REPORT: Results of Public Exhibition - Draft Blueridge Precinct Development Control Plan DCP23-004

DIVISION: Development and Environment
REPORT DATE: 28 July 2025
TRIM REFERENCE: ID25/1310

DRAFT
Blueridge Precinct
Development Control
Plan 2025

**RE: DRAFT DEVELOPMENT CONTROL PLAN
BLUERIDGE PRECINCT
DUBBO NSW 2830**

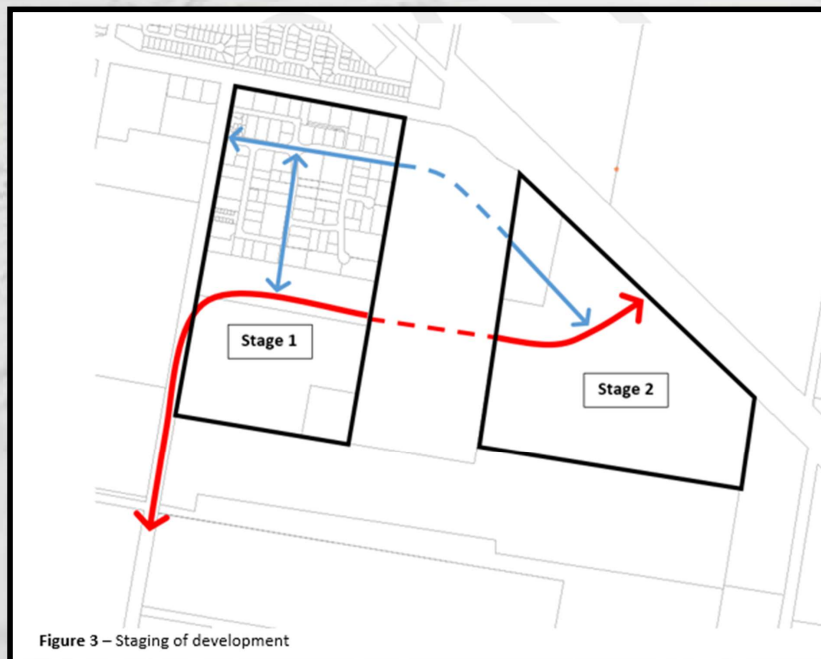
Staging	
Performance Criteria:	P1 Land is developed in an orderly manner to assist in the coordinated provision of necessary infrastructure.
Requirement:	A1 Staging is undertaken in accordance with Figure 3 . Staging Plans are included with any development application. The plans identify proposed sequencing, layouts, lot sizes, shapes, likely development densities and required infrastructure.

While a coordinated approach to development should be encouraged, suggesting that the eastern allotments cannot be developed until the western land is completed seems unnecessary. Should infrastructure provision be suitable, there should be no reason for any development delay. This is particularly important given the different zoning (E3 and E4) of the proposed stages.

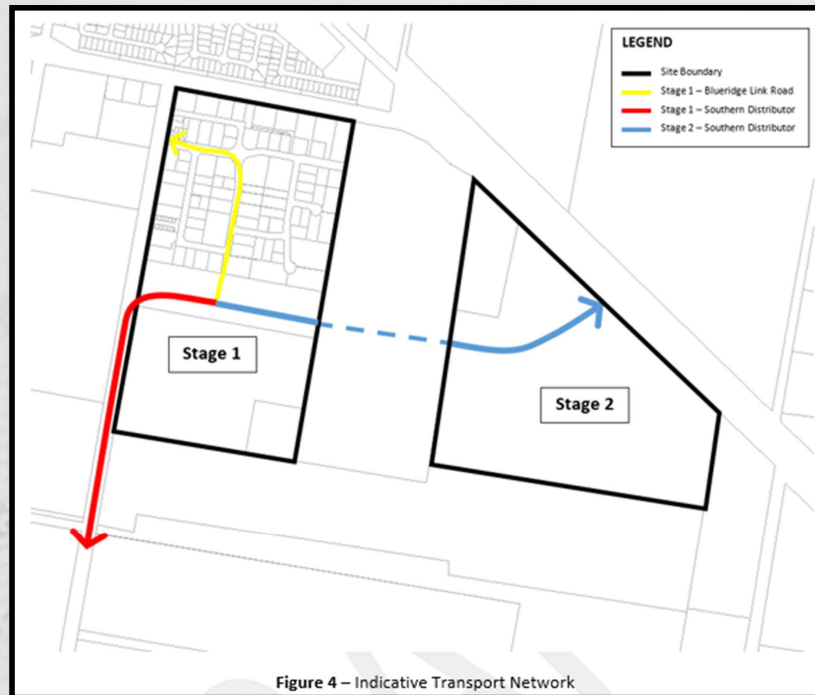
The format of this document is exceedingly poor, referring to figures located several pages away – as shown above, Figure 4 is found two pages ahead in the document. There is no need to make this document difficult to follow, and a revision in this respect is recommended.

It is disturbing to note the presence of a designated “Blueridge Link Road”, noting that this proposal is in the early stages of review and unlikely to crystallise. Reference to this proposed route should be removed from the document. The inclusion of this link road, prior to commencement of proper studies and consultation, is inappropriate.

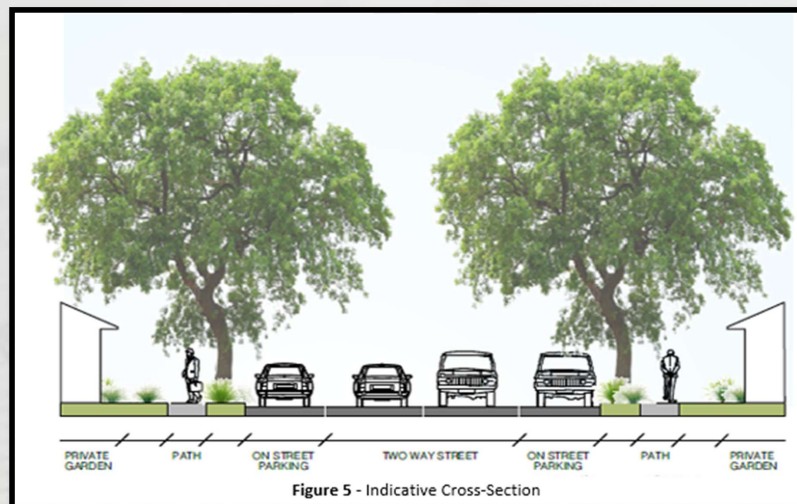
While an effort to make the site more pedestrian friendly is applauded, the footpath width of 1.5 metres is not indicated on Figure 5 – Indicative Cross Section.

With the standards that have been applied to development in the existing Blueridge Business Park, Figure 5 should have dimensions to provide design guidance. This figure is worthless from a design perspective. Dubbo Regional Council know what widths they want roads, verges, footpaths, and setbacks to be. These dimensions should be shown on Figure 5. It is also noted that this figure does not provide a suitable carriageway for heavy vehicles. A separate figure, with dimensions, could be provided for the two classes of road as currently designed in Blueridge Business Park, being a 28m corridor (Blueridge Drive) and a 22m corridor (all other roads within the park).
